Community Association Response

Re: LOC2022-0215

Previous Community Association Response

RE: LOC2022-0215

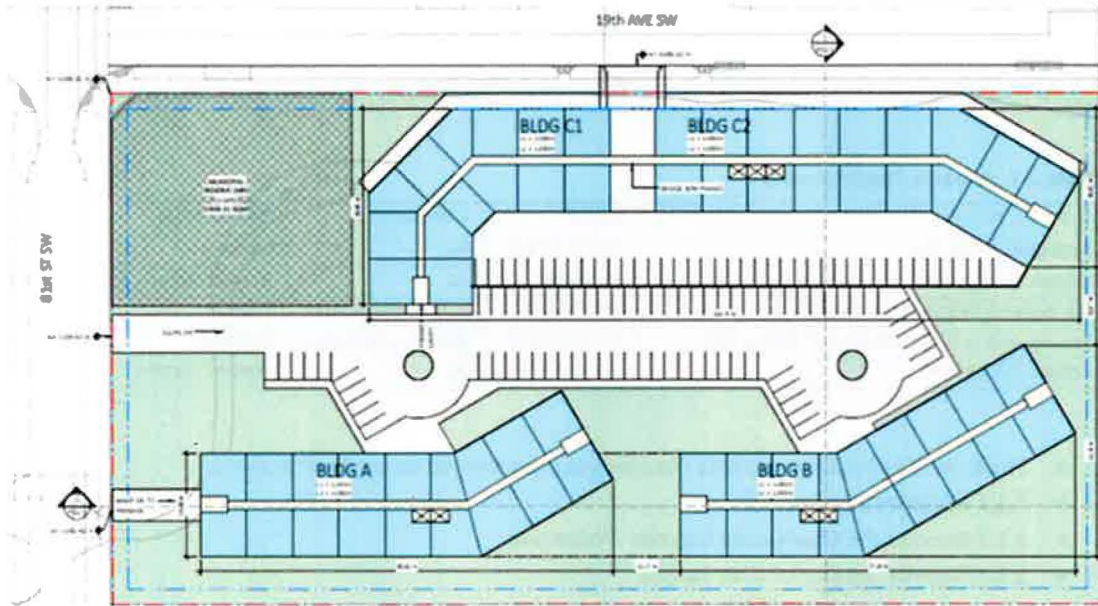
Several meetings with the developer were held without the applicant. We are very appreciative that the developer has invested the time, as well as presenting their concepts with candor and transparency. At these meetings the developer has suggested the vision presented by the applicant would not be achievable and the following has been presented as more representative of what would be proposed at the development permit stage.

Unfortunately, many of the concepts presented in the applicant's vision have not been incorporated. The community is left with concerns as to what the final design might be.

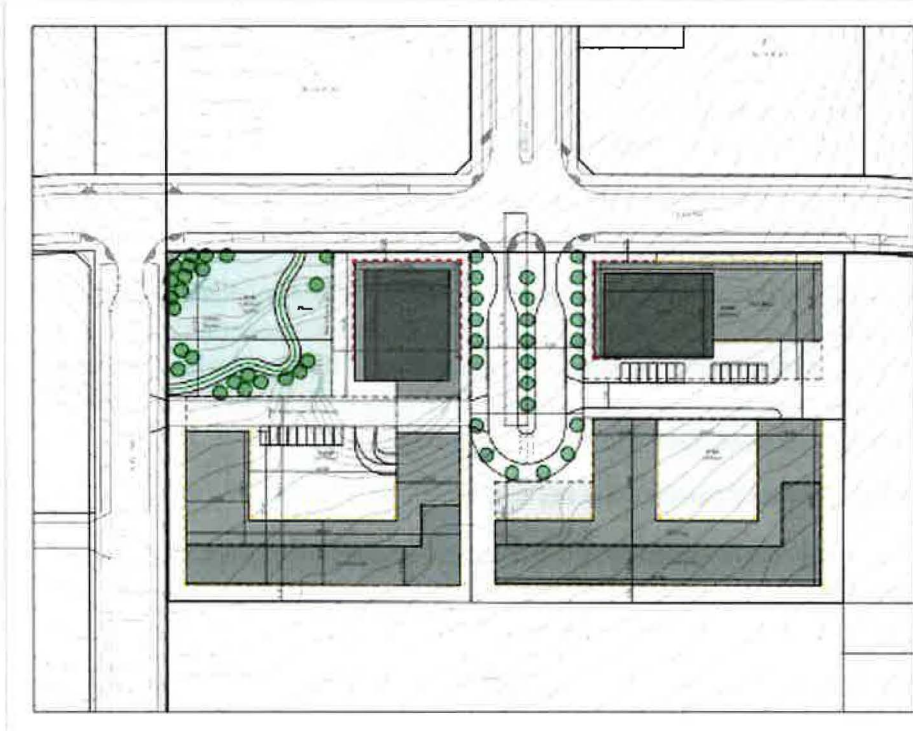
This part of our Community, needs to adhere to the idea of the Liveable Street along 19th Ave SW that encourages access by foot and non-motorized vehicles. The original vision in the ASP, was to limit the retail activation along the south side of the Liveable Street - 19th ave. The applicant has previously challenged this vision with the Orion development, and is again so doing this with this application.

While only at land use the revised plans and MR treatment direction from the city parks department moves the application further from the NAC concept in our opinion.

The latest plans presented

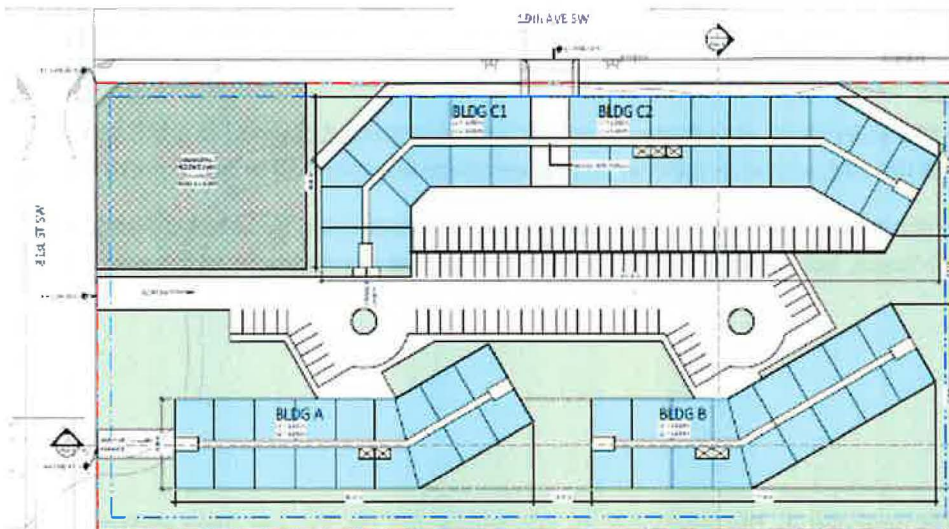
Contains :

- A standard accessway off of 19th ave, eliminating the entranceway that would have been the focus of the NAC
- A large surface parking lot
- Two 10 Storey and 2 6 Storey buildings
- Another playground in the MR / Central amenity space

While we understand that a land use application paints with a “broad brush”, the direction of the plans presented would not suggest an intention to create a true NAC space at the DP stage.

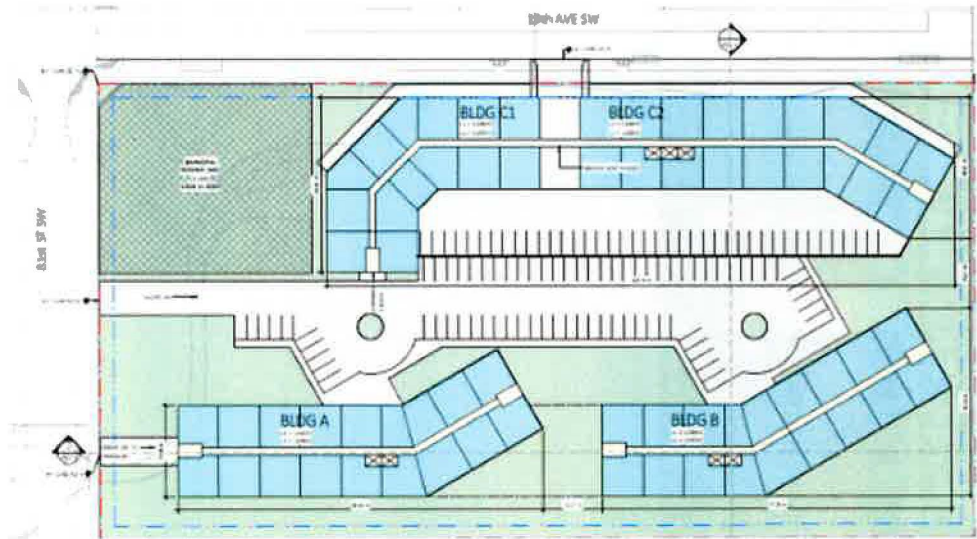
- Juniper LOC2023-0212 and DP2023-03051 - current proposed 117 units
- Wildflower LOC2018-0144 DP2020-2708 68 units built
- Azure LOC2023-0104 DP2023-08134 34 units multifamily vs single homes + amenity building

For a total 219 units

If we calculate 1.5 cars per unit an additional 102 cars would be on 81st street then is in currently Identified in the TIA. Additionally, an amenity building and different buildforms then noted in the TIA could alter the calculations.
